**NO:** SW-109  
**DATE:** September 2015

**PRODUCT:** A6E DIP Switch  
**TYPE:** **Discontinuation** Notice

**A6E DIP Switch Series to be DISCONTINUED, replaced by the A6E-N**  
**March 30, 2016**

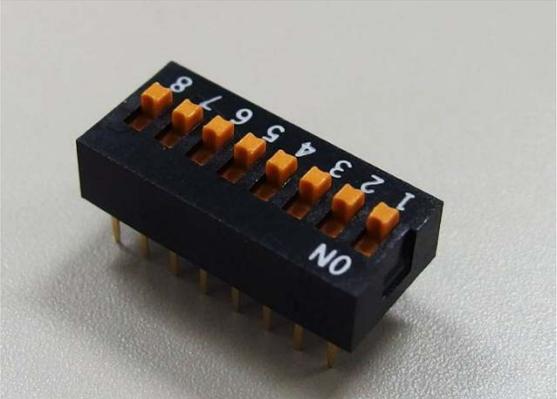
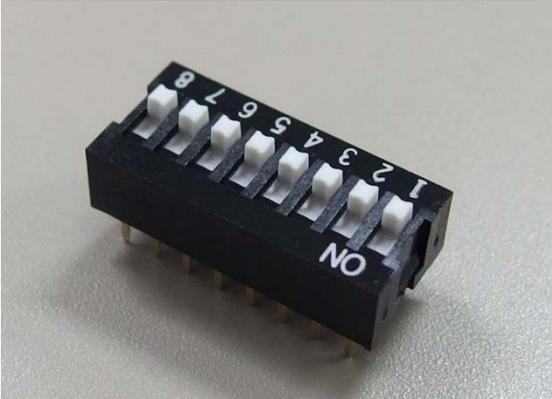
**Caution on suggested replacement:**

The actuator color is orange for the A6E. The actuator color is white for the A6E-N.  
There are dimensional differences between the A6E and A6E-N. The A6E-N has a smaller body dimensions;  
Height difference: approx. 0.15 mm  
Width difference: approx. 0.2mm (per pole).

→ Therefore, please consider the suggested replacement carefully, for new and existing designs.

**A6E-N -- Differences from discontinued product:**

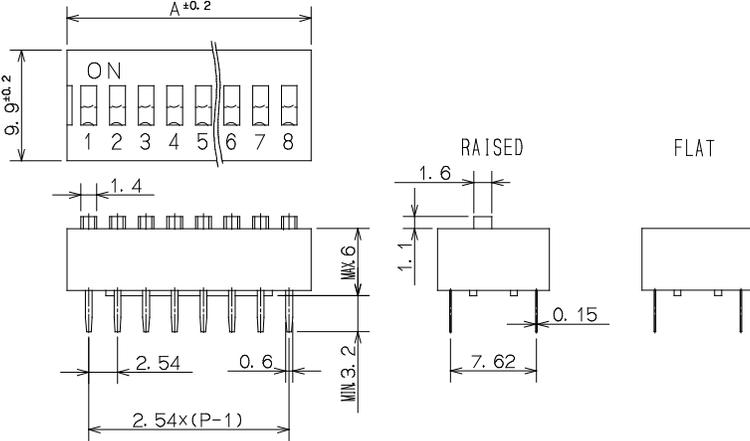
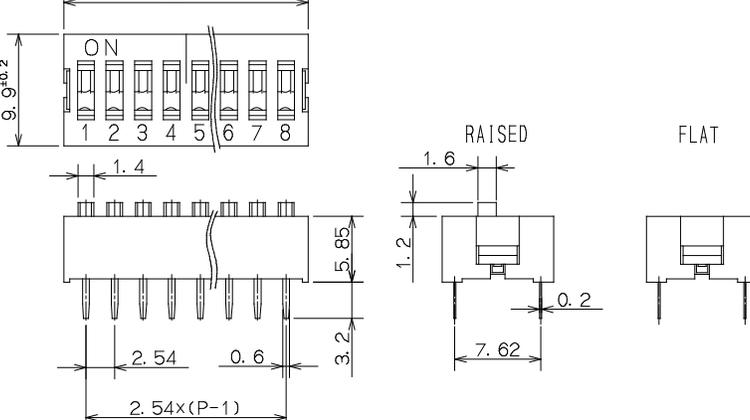
Recommended replacement Model	Body Color	Dimen-sions	Wire connection	Mounting Dimensions	Charact-eristics	Operation ratings	Operation methods
<b>A6E-□101-N series</b>	--	*	**	**	**	**	**
<b>A6E-□104-N series</b>	--	*	**	**	**	**	**
